ADMINISTRATIVE APPLICATION CHECKLIST

Applicant: OXY USA INC. **OGRID Number:** 16696
Well Name: TAILS CC 10-3 FEDERAL COM 32H **API:** 30-015-48880
Pool: PURPLE SAGE WOLFCAMP **Pool Code:** 98220

Re: *Application for Administrative Approval of Non-Standard Location
Tails CC 10-3 Federal Com 32H – Purple Sage Wolfcamp
Surface – 220' FSL 1760' FWL Unit N Sec 10 T24S R29E
First Take Point – 100' FSL 990' FWL Unit M Sec 10 T24S R29E
Last Take Point – 100' FNL 990' FWL Unit D, Lot 4, Sec 3 T24S R29E
Bottom Hole – 20' FNL 990' FWL Unit D, Lot 4, Sec 3 T24S R29E
Eddy County, New Mexico*

Re: *Application for Administrative Approval of Non-Standard Location – 1280-acre HSU
Tails CC 10-3 Federal Com 31H - 38H, & 312H – Purple Sage Wolfcamp
Eddy County, New Mexico*

CC: Tails Wolfcamp 1280-acre HSU Well Layout

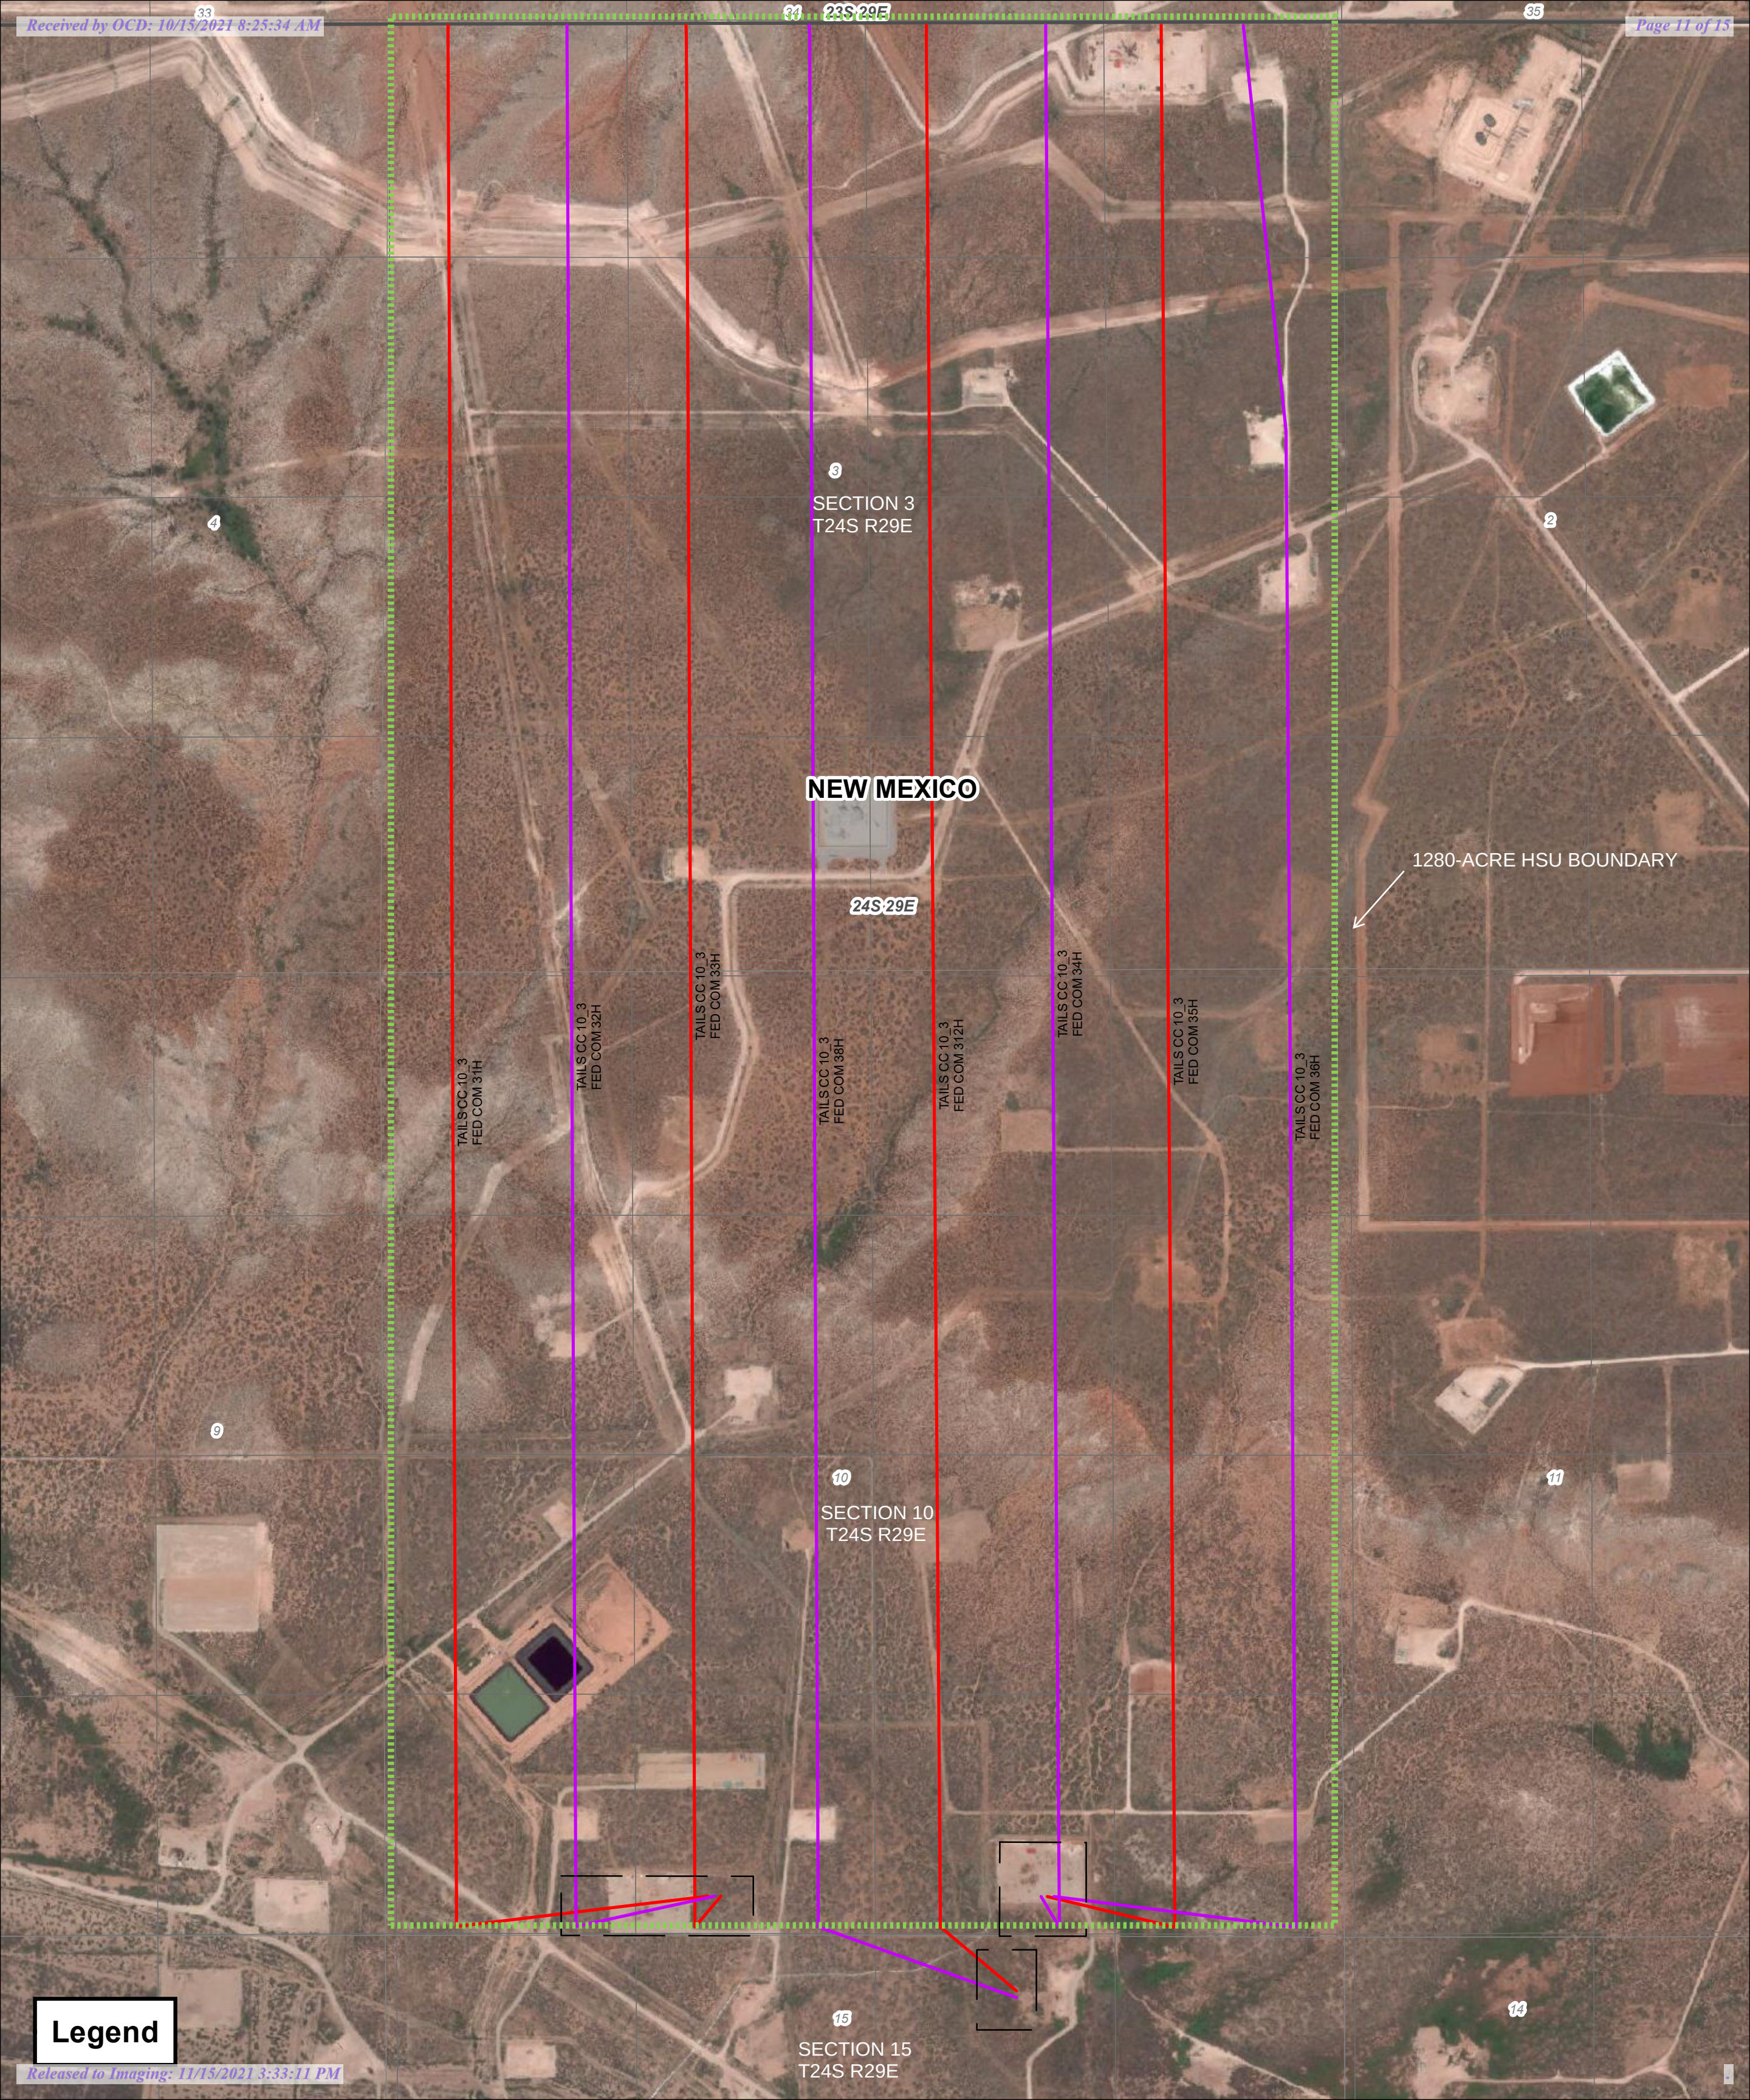
The Purple Sage; Wolfcamp is regulated to 320 acres for a projected horizontal spacing unit allowed by order. Any irregular spacing unit (greater or less HSU) needs to be approved by an OCD Administrative Application of a NSP. **Unless the operator can prove that the horizontal spacing unit stated for all these wells are allowed by other means. If so, what are those?**

OXY USA Inc. respectfully requests administrative approval of a non-standard location on the below list of Tails CC 10-3 Federal Com wells. The #38H well will be the defining well for the 1280-acre HSU and for the proposed completed wells in the Purple Sage Wolfcamp pool, Pool Code 98220. Attached is the well layout for the 1280-acre horizontal spacing unit for the Purple Sage Wolfcamp pool.

Here is a letter and the well layout for the PSW spacing unit. Let me know if this works or if I need to add in anything.
